# Fire technical assessment

**Name of sponsor:** Bygcom A/S  
**Product name:** Fermacell 1S32 – EI90  
**File no.:** PHA11192I  
**Date:** 03-06-2019  
**Pages:** 5 **Encl.:** 1  
**Ref:** MKL / NOL

# Symmetrical non-loadbearing wall

Fermacell 1S32 som Fermacells opbygning - EI90  
Max. 3m høj

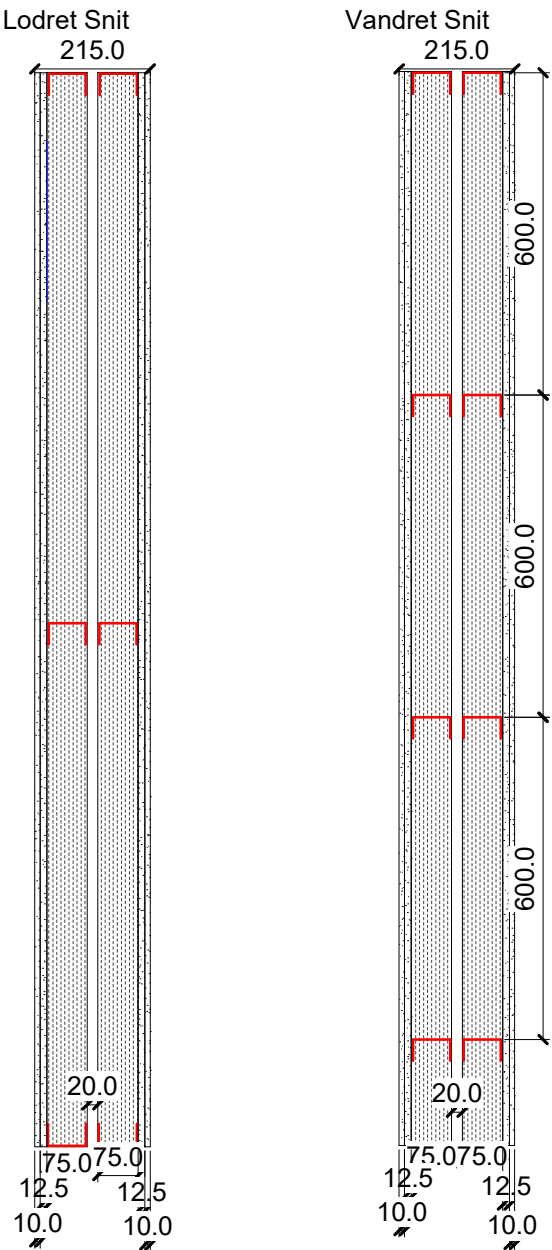
The construction shown on the attached drawing consist of two layers of Fermacell fibre board (10 + 12.5 mm) on one side and one layer of 12.5 mm Fermacell fibre board on the other side of two rows of c/c 600 mm steel studs with a width of 75 mm and a steel thickness of 1.2 mm designated Bygcom 75x1.2. The two rows of studs are placed 20mm apart. Stone wool insulation with a nominal density of at least 30 kg/m<sup>3</sup> is mounted between both rows of steel studs.

The changes to the assessed wall is the type and thickness of the studs and the added extra row of studs with stone wool insulation. The change in stud type and the increase in stud and the extra row of studs will not deteriorate the performance of the wall and can in some cases improve the stability of a wall during a fire test.

Based on the given documentation, DBI assesses that the wall shown on the attached drawings fulfils the requirements for a non-loadbearing wall with the classification EI90.

- The following changes are allowed (taken from the DIAP in EN 1364-1:2015)
  - Decrease in height (max 3000 mm)
  - Increase in the thickness of the wall (minimum 215 mm thick)
  - Increase in the thickness of component materials
  - Increased in the width of the studs
  - Decrease in linear dimensions of boards but not thickness
  - Decrease in stud spacing
  - Decrease in distance of fixing centres
  - Increase in the number of horizontal joints
  - Unlimited increase in the width of the wall
- All other details must be constructed as described in test report PG11026
